Work Order ID 136406

Item Name: Quick Release Heli-Utility-Basket™ Long, HD Lid, Spacepod™/Squirrel Cheek Comp.

DART SERVICE INSTRUCTION

TO AMEND INSTALLATION INSTRUCTIONS D350-607-3 Rev.D,
INSTALLATION INSTRUCTIONS D350-607-4 Rev. C AND
INSTRUCTIONS FOR CONTINUED AIRWORTHINESS ICA-D350-607 REV. 6
REF TCCA STC: SH94-14
REF FAA STC: SR00213NY
REF EASA STC: EASA.10016996
REF BRAZILIAN STC: 2007S03-03/-04/-05/-06

FIGURE 1: INSTALLATION OF D4775-041 FWD STRUT

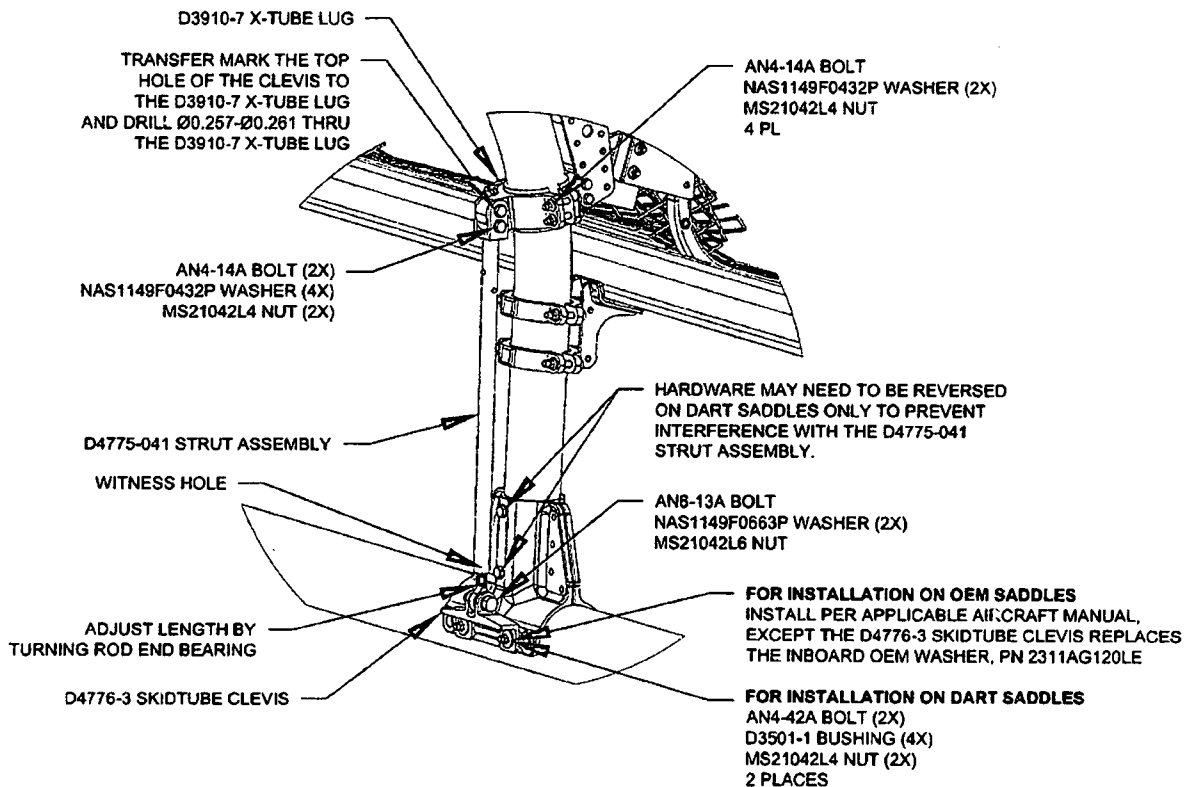
3.1 Substitute the Forward Lower D3910-5 X-Tube Lug with the D3910-7 X-Tube Lug as shown in Figure 1.

3.2 Install the forward D4775-041 Strut Assembly. Transfer mark from the upper hole on the clevis of the D4775-041 Strut Assembly to the D3910-7 X-tube Lug and drill thru the lug $\varnothing 0.257$ - $\varnothing 0.261$ as shown in Figure 1. Touch up chemical conversion coating per MIL-DTL-5541. Check the witness holes located at the bottom end of the D4775-041 Strut Assemblies to ensure that the thread from the rod end extends past the witness hole.
Torque MS21042L4/-4 nuts to 50-70 in-lbs (5.7-7.9 N-m). Torque MS21042L6/-6 nuts to 160-190 in-lbs (18.1-21.5 N-m).
